qathet
REGIONAL DISTRICT

ADDENDUM #2

Request for Quotes

FIRE FACILITY TRAINING STRUCTURE

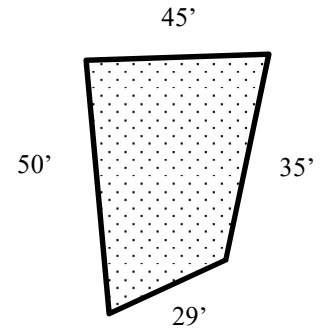
What footprint is available for this structure?

The surface area available for the structure is approximately 45' x 35' x 29' x 45'.
